ENSTROM HELICOPTER CORPORATION

SERVICE DIRECTIVE BULLETIN NO. 0049

Subject: Main Rotor Transmission Mount Bolts

Model: F-28C, S/N 451-2, 452-2, 453, 454-2, 455-2, 456-2, 457, 458, 459, 460-2, 462, 463-2 and 464-2.

Figure 1

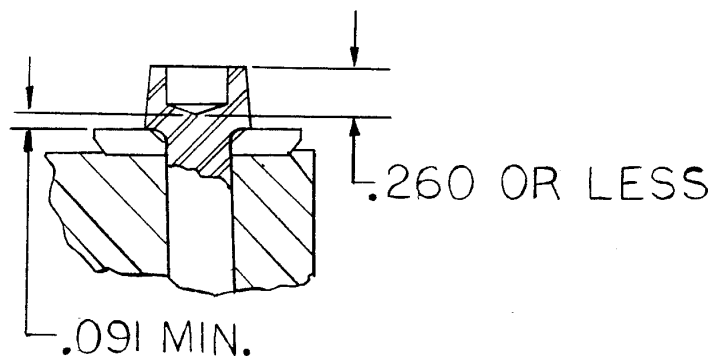
It has been found that several of the NAS146R-57 internal wrenching bolts to have defectively formed heads. The bolts in question are in one lot of the -57 length only and are the mounting bolts for the main rotor transmission. Therefore a strong possibility exists that some of these bolts may be in service.

The depth of the internal wrenching hole, should be measured from the top surface of the bolt, as near to center as possible. This depth should not be greater than .260 inches as indicated in Figure No. 1, if the depth measured is greater, the bolt should be removed and replaced with an airworthy bolt.

The following should be accomplished on or before the next 100 hour inspection.
